Assessment Officer Report

PA2503869 – 1 Conway
Street, Kilmore.
St Patricks Primary School

Officer Assessment Report
Development Approvals & Design

Figure 8: Maintenance Building

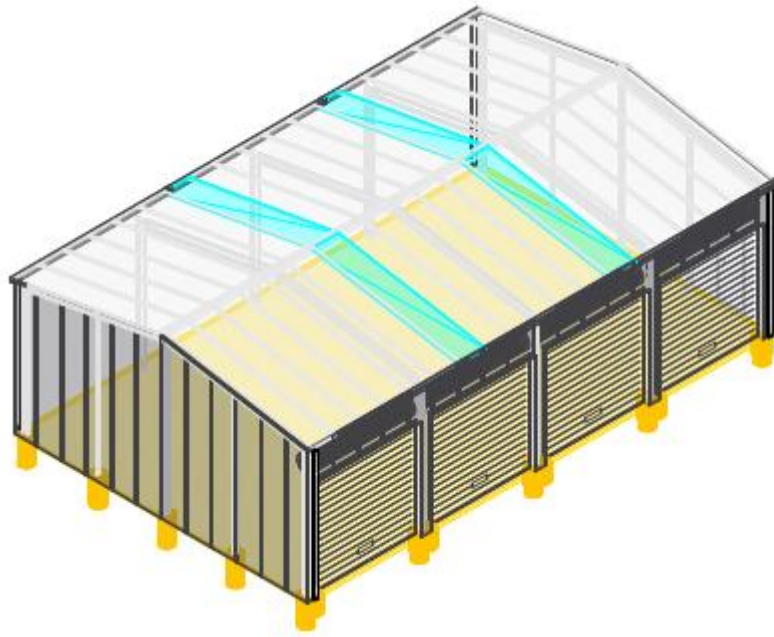
46. The maintenance shed is a simple colorbond shed with 4 bays for access to the internals. The simple built form is typical of rural sheds within the broader area.

51. The new maintenance shed will be located adjacent to land subject to the Heritage Overlay (HO103), the proposed works have been reviewed by councils' heritage advisor who has made the following comments:

52. The plans assessed by the heritage advisor showed the location of the shed closer to Assumption College boundary and within the heritage overlay. The applicants have submitted updated plans which have relocated the new maintenance shed to be sited outside of the heritage overlay and will not result in the loss of any trees.
